URBAN DESIGN BRIEF

SITE PLAN CONTROL

SUBJECT SITE: 541-561 SOMME STREET

PREPARED FOR: BLACKSTONE GRANITE

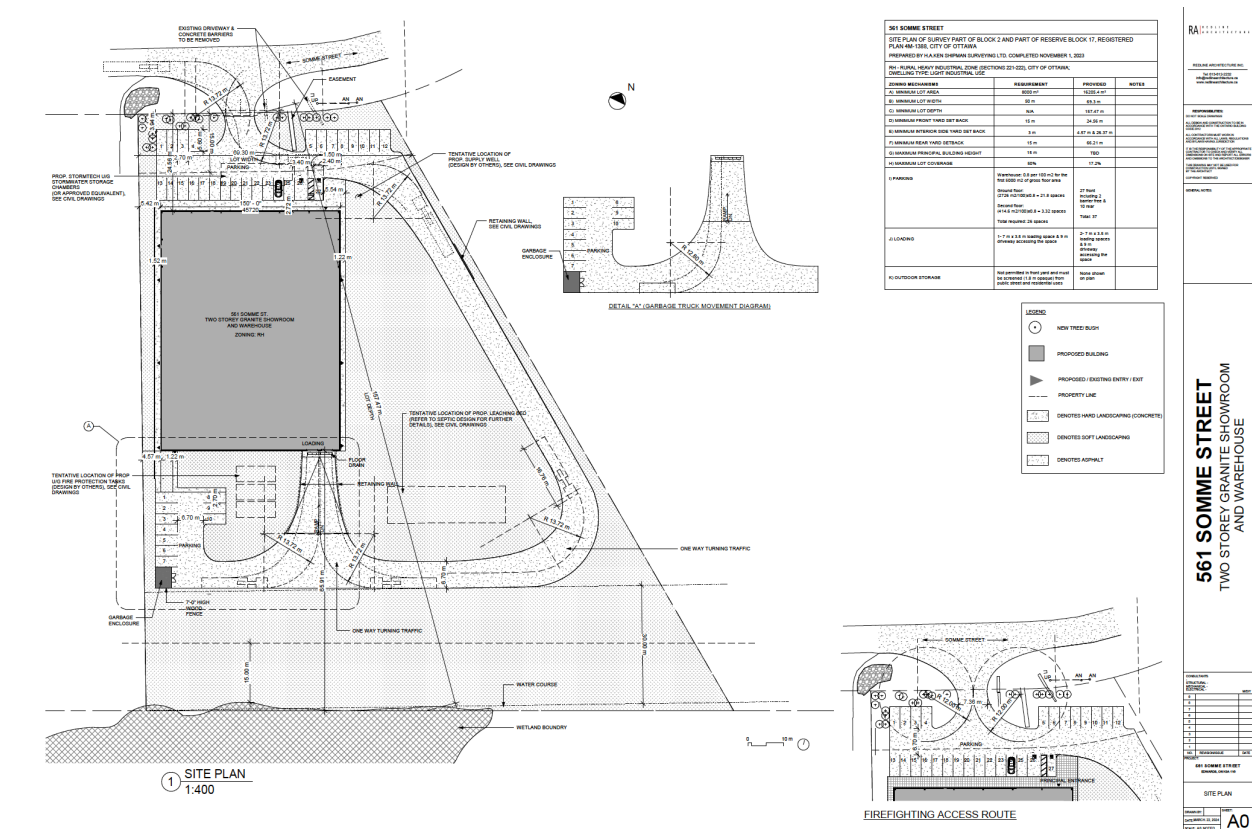
We recommend providing landscaping and new tree planting at the front of the property.	Trees and landscaping have been added to the front of the property. In working with HydroOttawa, we have learned that there is an easement, poles and tie-backs that significantly encumber the frontage. Therefore, no landscaping is provided where hydro infrastructure is existing.

What is happening in the large areas of land left over at the rear of the site and beside the building? Please indicate on the site plan/landscape plan and provide landscaping and trees if possible/suitable.	This area has been reserved for possible future development.
--	---
